NEW MEXICO
ENVIRONMENT DEPARTMENT

Hazardous Waste Bureau

**SUBJECT: SEPTEMBER 5, 2009 API SEPARATOR OVERFLOW REPORT
WESTERN REFINING, SOUTHWEST INC., GALLUP REFINERY
EPA ID NO. NMD000333211
HWB-GRCC-MISC**

SAMPLING PLAN
(API OVERFLOW) ON 09/05/09

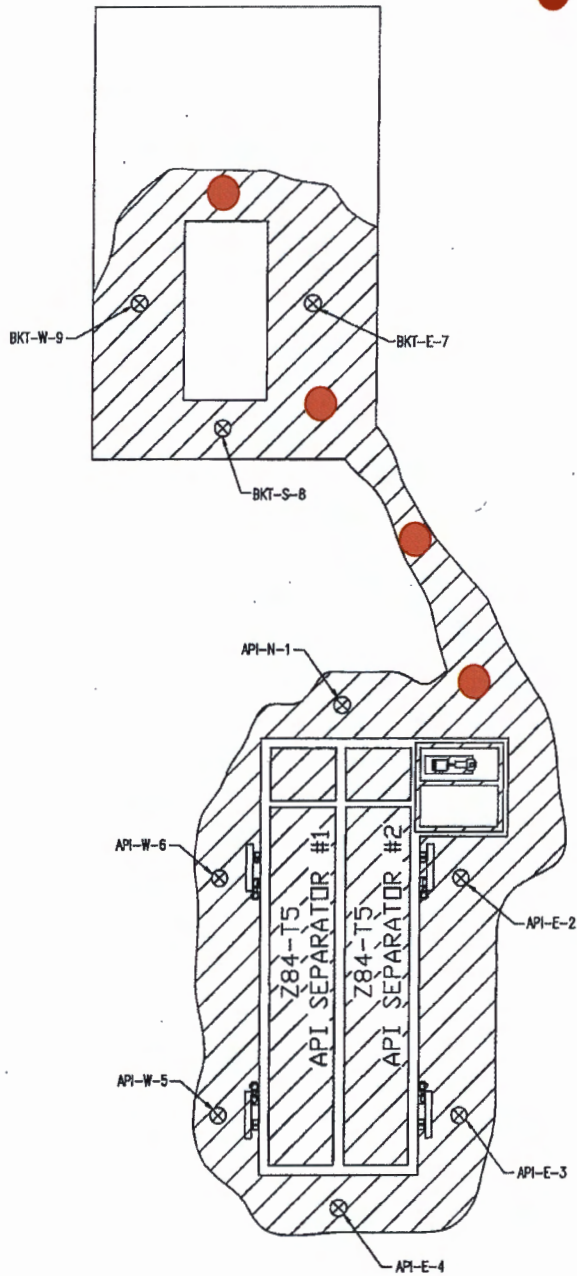
- a. The Permittee must remove additional contaminated soils in the vicinity of the API Separator and the Baker Tank within the hatched area identified in the "Sampling Plan" figure (attached).

- b. The Permittee must collect confirmation samples from the approximate locations of all of the former sampling locations with the exception the roll-off box location. The Permittee must also collect samples from the additional sample locations identified in the attached figure. All samples must be collected from the limits of the excavation not to exceed six inches in depth.

- c. All confirmation samples must be analyzed for DRO extended. In addition, samples collected from locations API-E-2 and BKT-E-7, BKT-S-8, and BKT-W-9 must also be analyzed for gasoline range organics.

- d. The confirmation samples must not exceed organics concentrations of 200 mg/kg, if such concentrations exceed 200 mg/kg then additional soil removal will be required until detected concentrations are less than 200 mg/kg.
